SOUTH HOLLAND DISTRICT COUNCIL

Reference: H14/0579/93 Received:02-JUL-93 Type:CONDITION COMPLIANCE

Description: Fencing, parking and material details submitted (Conditions 2, 3 and 4 of H14/0222/93 refers)
Location : Flaxmill Lane Pinchbeck
Spalding Lincs

project: PROPOSED 6Nº TERRACED HOUSES, FLAXMILL LANE, PINCHBECK, SPALDING, LINCS

Block Plan 1:250.

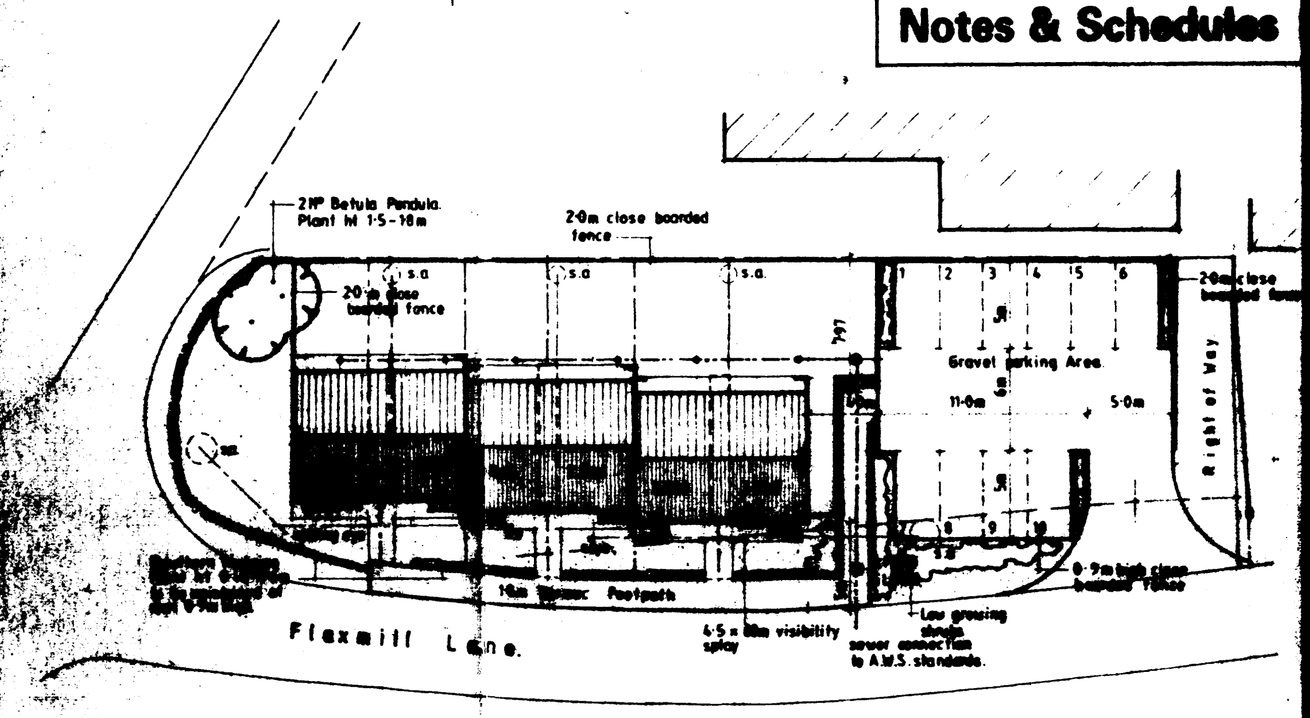
Full details of proposed landscaping required viz: number; species; planting heights, of all plants.
(N.B. Additional tree planting to car parking area would be beneficial. You are advised that gravel parking may not be acceptable; alternative block or tarmac construction suggested so that parking spaces could be clearly delineated).

Further to your letter of the 10th August 1993, we would confirm that the screen fences will be constructed of 2.0m high close boarded timber in accordance with B.S. 1722 Pt.5 1972 and that 215 x 215 brick piers will be positioned at 2.0m centres along the length of the fence and at all changes of direction.
